Service Bulletin

Subject:	t: SQUEAKING/GRINDING NOISE FROM REAR BRAKE	Bulletin No:	04-003/15
		Last Issued:	09/16/2015

2014-16 Mazda3 vehicles with VINs starting with JM1

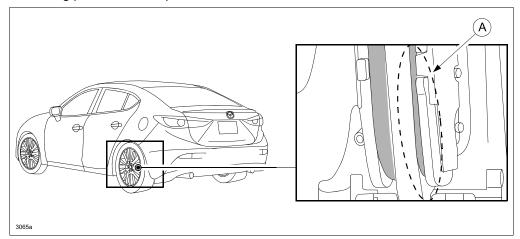
Some vehicles may experience a squeaking/grinding noise from the rear brake even after the brake pedal is released. Upon inspection, the caliper mounting support is corroded and the disc pad is abnormally worn out (A). This is caused by vehicle usage in an area using road salt. The surface of the mounting support may swell from corrosion causing premature disc pad wear and brake noise.

To correct the problem, an improved caliper mounting support has been newly established as a service part. The anti-corrosion surface treatment has been changed from Zn to Zn-Ni plating.
